APPLICATION NO.	FILING DATE	FIRST NAMED INVENTOR	ATTORNEY DOCKET NO.	CONFIRMATION NO.
10/537,418	08/10/2005	Godwin Cork David	F-8690	1873
	7590 09/24/200 HAMBURG LLP	EXAMINER		
122 EAST 42ND STREET			MENON, KRISHNAN S	
SUITE 4000 NEW YORK, NY 10168			ART UNIT	PAPER NUMBER
			1797	
			MAIL DATE	DELIVERY MODE
			09/24/2008	PAPER

DETAILED ACTION

Claims 1,4,5 and 8-10 are rejected under 35 U.S.C. 102(b) as being anticipated by, or in the alternative, under 35 USC 103(a) as obvious over, Lorey et al (US 4,995,974).

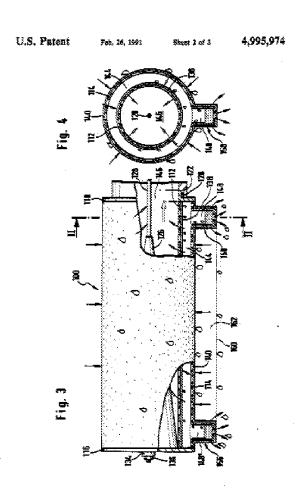
Lorey teaches (see fig below) an inner tube (112) with open top and closed bottom, having a hydrophobic membrane (138) around it, and located inside an outer tube (114), outer tube having an outlet in the bottom (156) and vent at the top (158). Membrane is PTFE and the pore size overlaps the range claimed (column 3, lines 3-9 and 45-50).

The reference teaches the outer tube also as covered with a PTFE membrane, the whole thing installed in a container or housing, and that the figures 3 and 4 are for horizontal operation. However, these details do not disqualify the reference, claims are open-ended. Moreover, the hydrophobic membrane would pass the organic liquids through the membrane from the outer tube; and the pores of the membrane would also allow air venting. Oil/water separation is intended use.

Material of outer tube is plastic or glass or metal as in claim 10.

With respect to claim 4, the inner tube has a wider (flanged) top.

Regarding claim 5, applicant elected this claim as readable on figure 1, even if claim 5 appears to be directed at figures 6-8, and thus is considered as an obvious equivalent of applicant's fig 1. The bottom surface of inner tube formed by the cone (126) in side the inner tube has a slope as claimed.

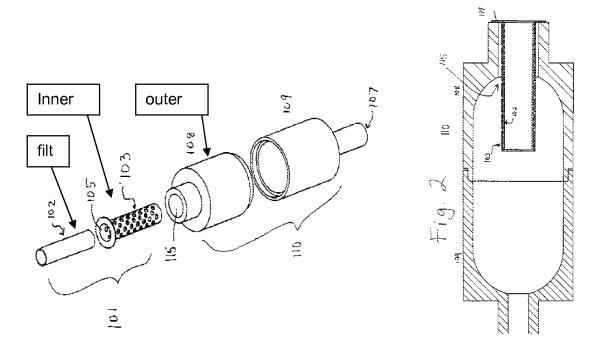
Details of claims 1,4 and 8-10 are clear from the exploded view of the device shown above, which are figures 1 and 2 of the Hunicke-Smith reference. Material of the outer tube is plastic or glass. Membrane is Teflon, pore size can be as desired, and also in the claimed range – see paragraphs 34-36. Oil/water separation is intended use.

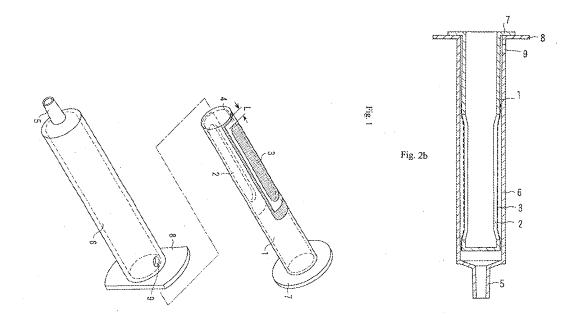
Applicant's fig 2b - see applicant's fig 1 and 2b reproduced below. In the reference, the 'large diameter upper end' of the inner tube (the flange) rests or stops on the rim or upper end of the outer tube as in claim 4.

Regarding the vent as recited in claim 1, since the inner tube is only resting over the top rim of the outer tube as seen in the figures of the reference (no tight seal), the top opening (mouth) of the outer tube functions as a vent. Also, providing a vent hole when necessary would be within the skill level of one of ordinary skill in the art, and such vents are also well known in the art.

Alternately, if one were to follow applicant's arguments, then the membrane can be the inner tube and the perforated tube can be the outer tube, which has holes or perforations for venting as well as draining the liquids.

Claim 5 is considered as an obvious equivalent of applicant's fig.1, and thus obvious over this reference.
